SUNDRY NOTICES AND REPORTS ON WELLS
Do not use this form for proposals to drill or to re-enter an abandoned well. Use Form 3160-3 (APD) for such proposals.

8. Well Name and No.
Poker Lake Unit #321H

9. API Well No.
30-015-40771

BOPCO, L.P. respectfully request to update the well plan for the PLU #321H as well as change the casing set depth on our 7" production string. The new 7" casing point will be at approximately 7,823' MD/ 7,530' TVD, the safety factors for 7" 26 lb/ft N-80 will be changed to; Tension S.F 3.07, Collapse S.F 1.28, and Burst S.F. 1.72. Please see attached file for Weatherford updated well plan.

PROJECT: Poker Lake Unit #331H

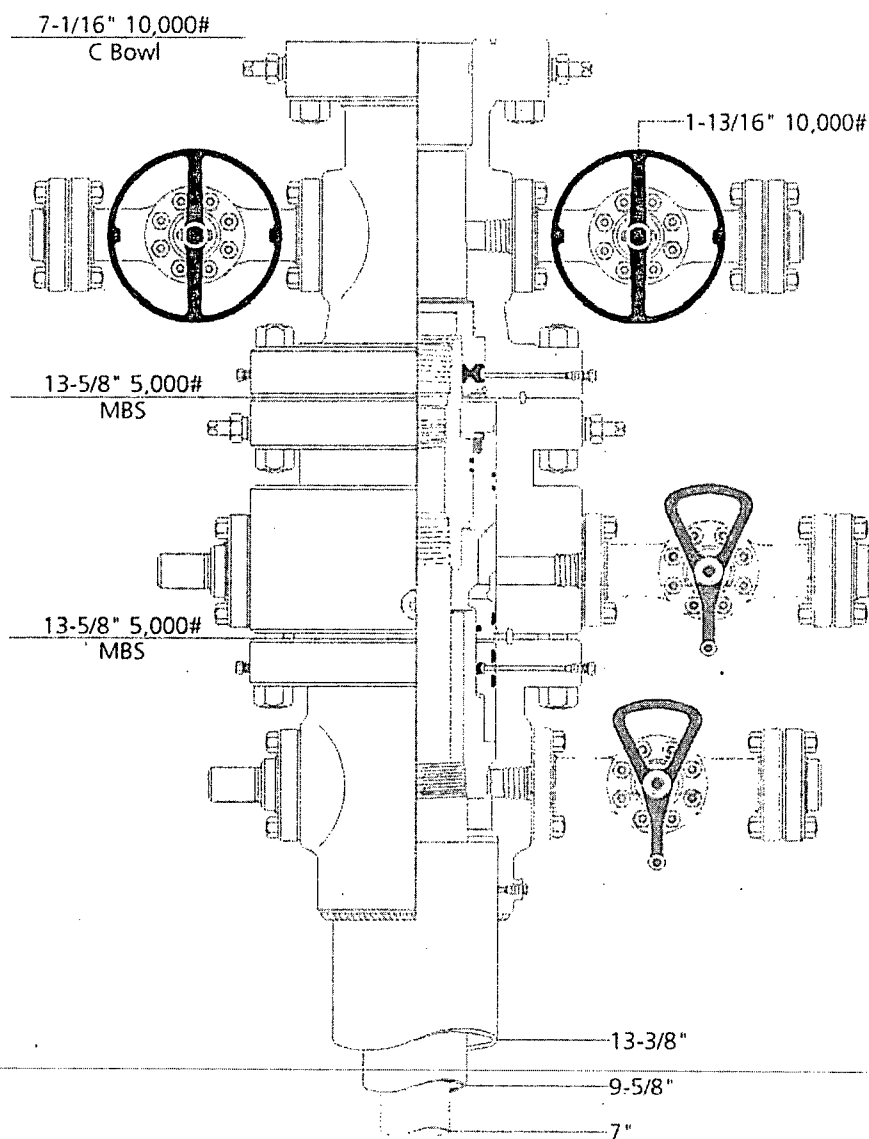
BOPCO, L.P. respectfully requests to change plans for BOP testing due to the utilization of the Cameron MBS wellhead. BOPCO L.P. respectfully requests to nipple up and test BOPE on surface casing to 3,000 psi high and 250 psi low which will cover testing requirements for the duration of the well. Please find attached the schematic of the wellhead. The field report from the Cameron representative and the BOP test information will be provided in a subsequent report at the end of the well.

3. **Operator has proposed a multi-bowl wellhead assembly. This assembly will only be tested when installed on the surface casing. Minimum working pressure of the blowout preventer (BOP) and related equipment (BOPE) required for drilling below the surface casing shoe shall be 3000 (3M) psi.**

- a. **Wellhead shall be installed by manufacturer's representatives, submit documentation with subsequent sundry.**
 - b. **If the welding is performed by a third party, the manufacturer's representative shall monitor the temperature to verify that it does not exceed the maximum temperature of the seal.**

- c. **Manufacturer representative shall install the test plug for the initial BOP test.**
 - d. **Operator shall perform the 9-5/8" and 7" casing integrity tests to 70% of the casing burst. This will test the multi-bowl seals.**

- e. **If the cement does not circulate and one inch operations would have been possible with a standard wellhead, the well head shall be cut off, cementing operations performed and another wellhead installed.**
